Access Compliance Report

Public Rights-of-Way

(Curb Ramps)

Intersection ID: 49933	Main Street: MARVIN_RD	Cross Street: WOBURN_RD	Location: NE
ADA ID: 6799832438C5	Ramp Type: Perp	Initial Pass/Fail: Fail	Overall Compliance: No
Severity Score: 37.5			
Codes/Mitigation Info/Possible Solution		Field Measurements/Component Compliance

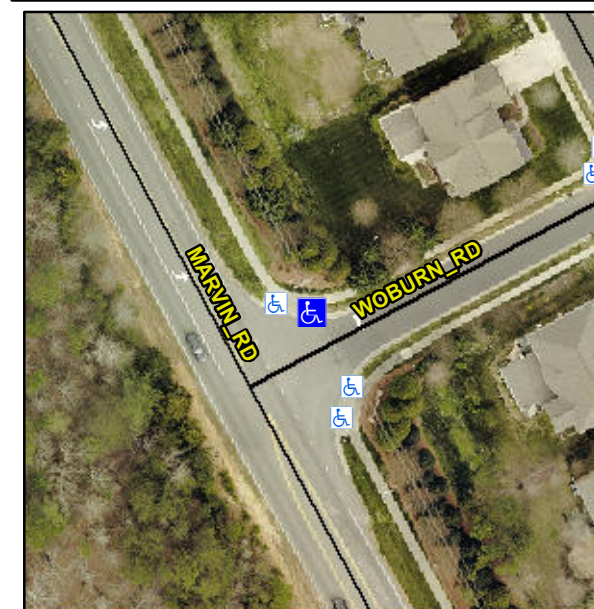
R304.2.2, R304.5.3

Compliance	Description	Data	Compliance	Description	Data
N/A	Ramp Length (in)	59.0	No	Ramp Slope (%)	9.1
Yes	Ramp Width (in)	48.0	No	Ramp XSlope (%)	8.0
N/A	Flare Type LT	N/A	N/A	Flare Type RT	N/A
N/A	Flare Slope LT (%)	N/A	N/A	Flare Slope RT (%)	N/A
N/A	Flare Traversable LT?	N/A	N/A	Flare Traversable RT?	N/A
N/A	Landing Length (in)	N/A	N/A	DWS Provided?	N/A
N/A	Landing Width (in)	N/A	N/A	DWS Contrast?	N/A
N/A	Landing Slope (%)	N/A	N/A	DWS Length (in)	N/A
N/A	Landing X Slope (%)	N/A	N/A	DWS Full Width?	N/A
N/A	Landing Curb? (Y/N)	N/A	N/A	DWS Offset (in)	N/A
N/A	Shared Landing?	N/A			
N/A	Gutter Ponding?	N/A	N/A	Gutter Slope (%)	N/A
N/A	Gutter Lip Ht (in)	N/A	N/A	Gutter X Slope (%)	N/A
N/A	Painted X Walk1?	No	N/A	Painted X Walk2?	N/A
	X Walk 1 Direction	To SE		X Walk 2 Direction	N/A
N/A	X Walk 1 Width (in)	N/A	N/A	X Walk 2 Width (in)	N/A
	X Walk 1 Slope (%)	2.0		X Walk 2 Slope (%)	N/A
	X Walk 1 X Slope (%)	5.8		X Walk 2 X Slope (%)	N/A

Remove & Replace Entire Ramp.
